WORK ORDER NON-CONFORMANCE / UPDATE

DESIGN	DRAWN BY	DART AEROSPACE LTD	REV. C
06.10.31	03.06.25	NEW ISSUE	
06.10.31	06.09.25	ADD D3196-5	
06.10.31	ADD SLOTS ON -1; REMOVED -5		
CHECKED	APPROVED	DRAWING NO.	SHEET 1 OF 3
06.10.31	06.10.31	D3196	
DATE	TITLE	BAR	SCALE
06.10.31	06.10.31	BAR	1:4

DRAWING NO: D3196	TITLE BAR	REV. C	DART AEROSPACE LTD ENGINEERING ORDER	D.E.O. NO. D3196-C-1	SHEET NO. SHEET 1 OF 2	SCALE NTS
DRAWN <i>ASS</i>	CHECKED <i>[Signature]</i>	MFG. APPR. <i>[Signature]</i>	APPROVED <i>[Signature]</i>	DE APPR. <i>[Signature]</i>		
DATE 08.08.27	DATE 08.08.28	DATE 08.08.29	DATE 08.08.29	DATE 08.09.04

D3196-1 BAR

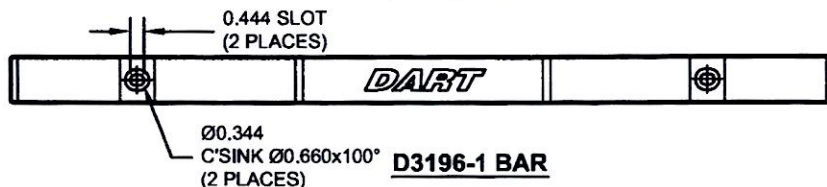
SHEET 1 MODIFY SLOT DIMENSIONING ON D3196-1 AS SHOWN:

NOTE: THIS CHANGE HAS BEEN DONE TO CLARIFY SLOT DIMENSIONS ONLY. NO CHANGES HAVE BEEN MADE TO THE PARTS
SEE NCR 08-051 FOR FURTHER INFORMATION
ALL OTHER INFORMATION REMAINS UNCHANGED

D3196-3 BAR

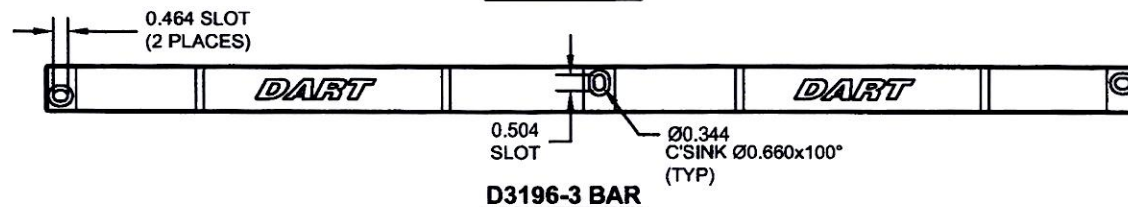
SHEET 2 MODIFY SLOT DIMENSIONING ON D3196-3 AS SHOWN:

D3196-4 BAR

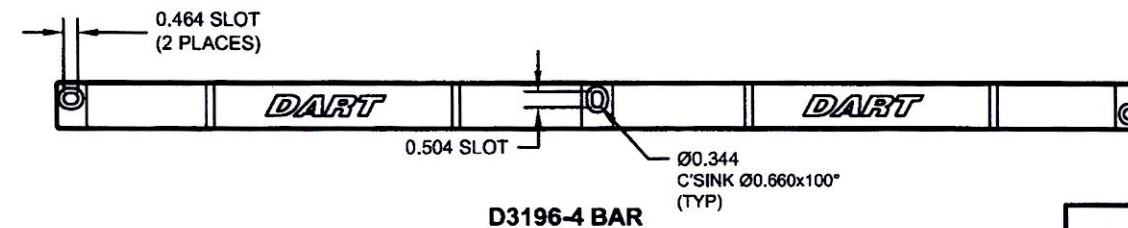
SHEET 3 MODIFY SLOT DIMENSIONING ON D3196-4 AS SHOWN:
